Applicants : James E. Marek
Appln. No. : 10/753,664
Page : 14

Amendments to the Drawings:

REMARKS

This response is to the Office Action mailed May 1, 2006.

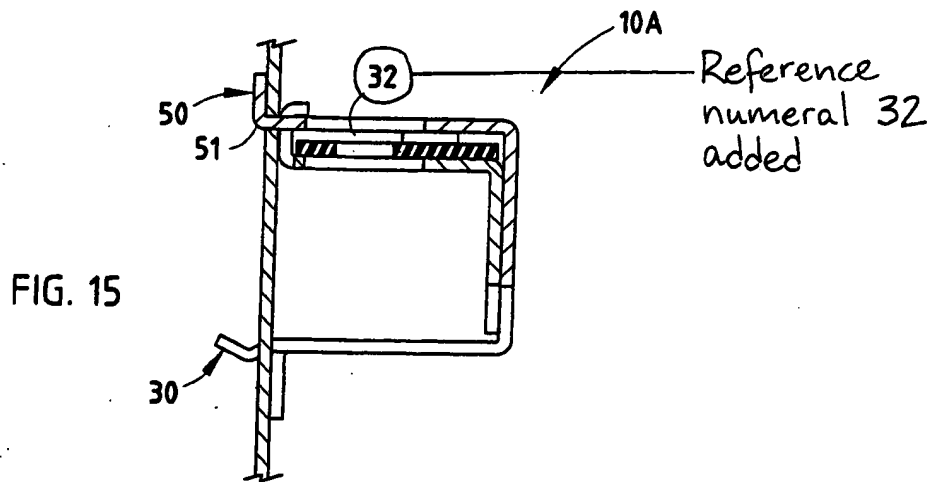
Reference
number 32
added

FIG. 21

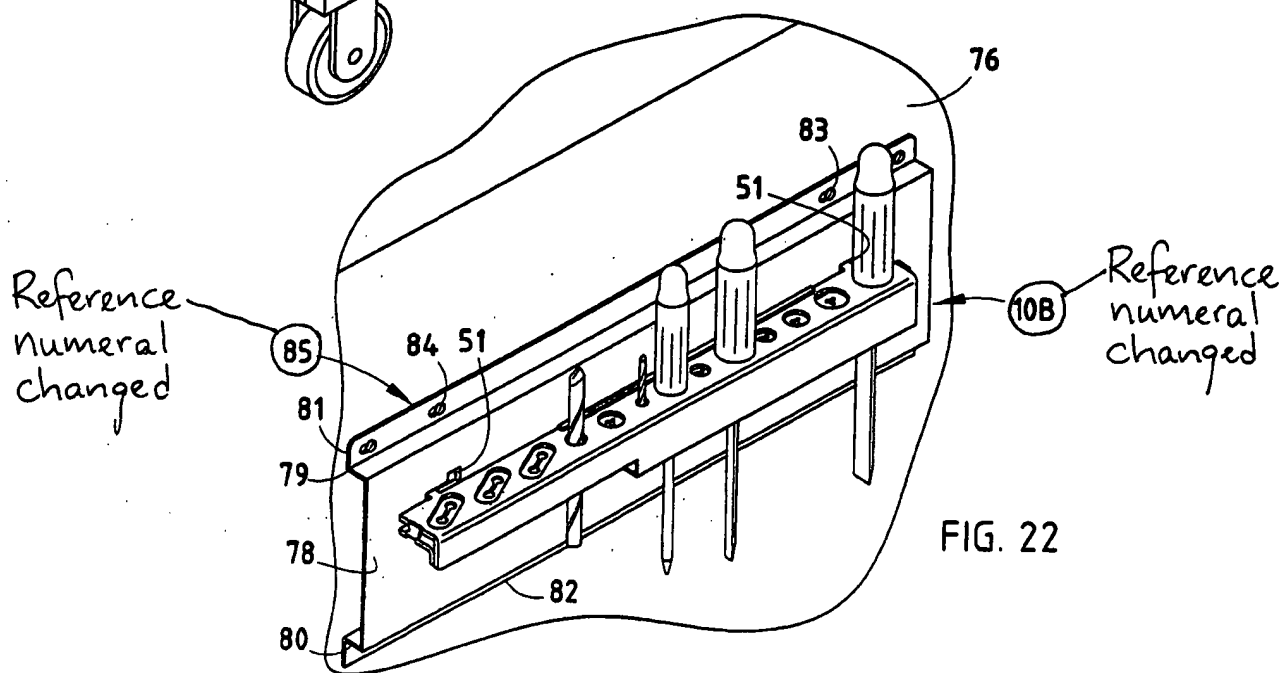
In Figs. 18, 20-22, reference numeral 10A has been changed to reference numeral 10B because reference numeral 10A was already used in Figs. 13-17. In Figs. 21 and 23, reference numeral 42A has been changed to reference numeral 42C because reference numeral 42A was already used in Fig. 11. In Fig. 22 reference numeral 77 has been changed to reference numeral 85 because reference numeral 77 was already used in Fig. 21.

FIG. 22

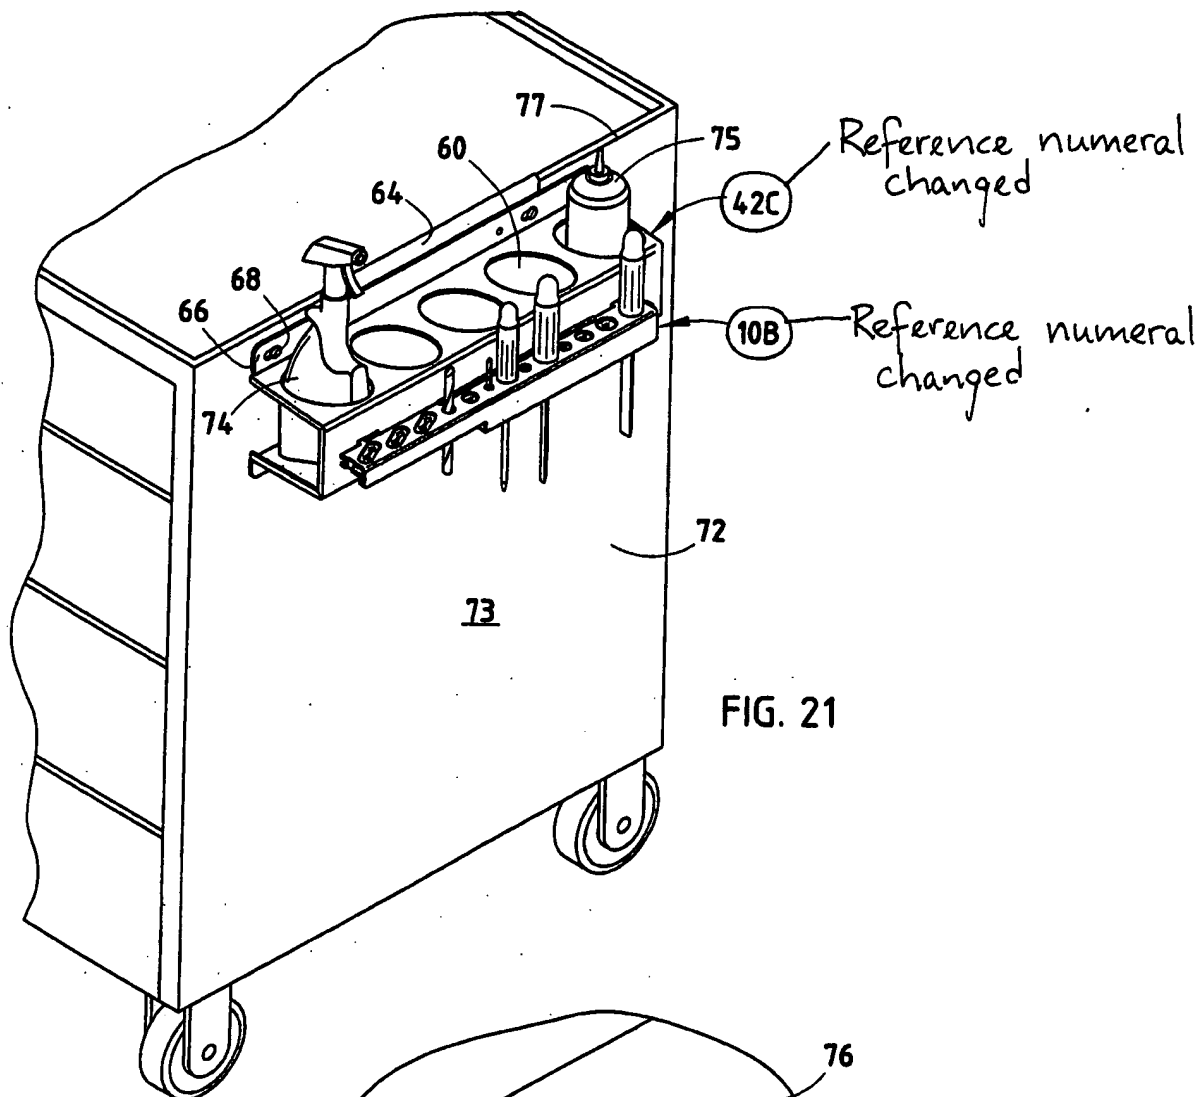
Reference numeral
changed
